Flight Procedures Cover Page	Task Action: Abbreviated Amendment	Task Type: IAP	Estimated Chart Date: 12/29/2022	APWS Task ID: F16EE8AF62AD4266B6054661CEB7A03F	APWS Project ID: 61734082BEF143B282F22FE04680452D
Procedure: RNAV (GPS) RWY 19 AMDT 1C		Enroute: NO	Specialist: Boone, Victor		Agreement Number:
Airport ID: KIRS			Airport City: STURGIS		State: MI
Facility ID:	Facility Type:	Flight Inspection Remark Type:			
<p>Procedure Comments:</p> <p>PENDING DATA USED.</p> <p>MAG VAR KIRS: OLD 4W-NEW 6W</p> <p>CONTACT INFO: CASIMIR TABAKA, AJV-A432 MANAGER, 405.954.7931</p> <p>8260-2 WIREP</p> <p>10/3/2022: THIS IS A CORRECTED COPY OF THE FORM APPROVED ON 8/24/2022 REMOVED CONTROLLER FROM REQUIRED CHARTING.</p> <p>10/19/2022: THIS IS A CORRECTED COPY OF THE FORM APPROVED ON 8/24/2022 PROFILEVIEW LINE 5 ADDED DIST TO THLD FROM 314 HAT:0.86</p>

RNAV (GPS) RWY 19

KIRSCH MUNI (IRS)

RNAV (GPS) RWY 18
KIRSCH MUNI (IRS)

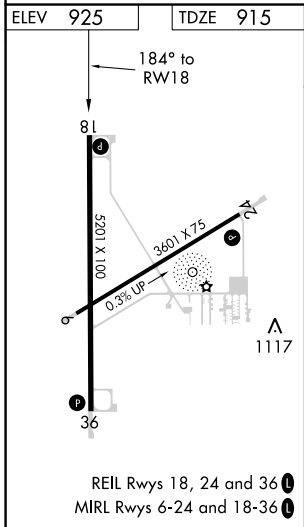
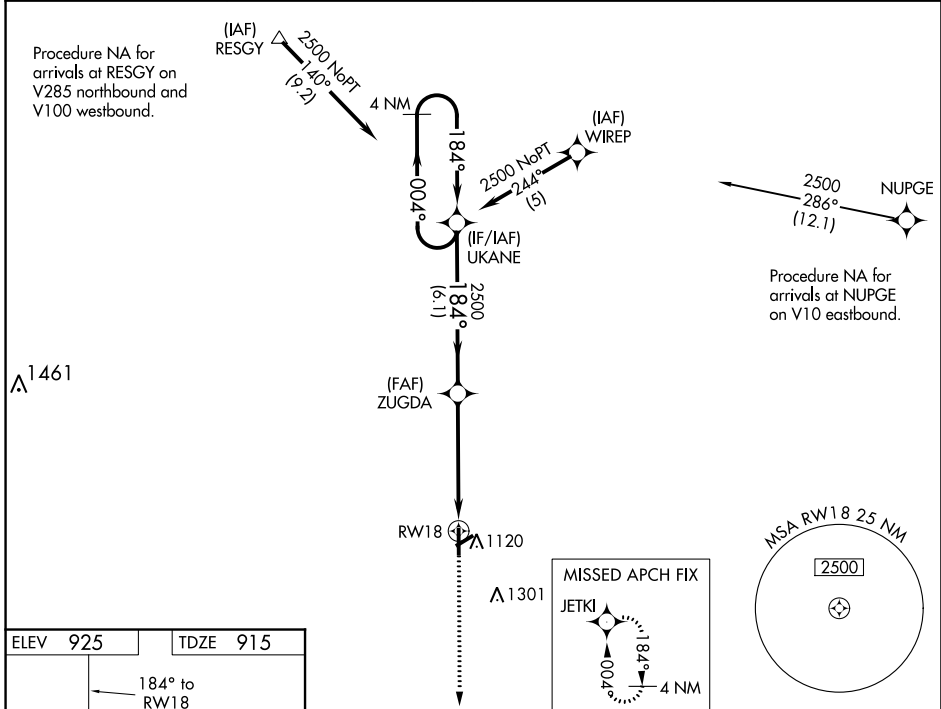
OLD
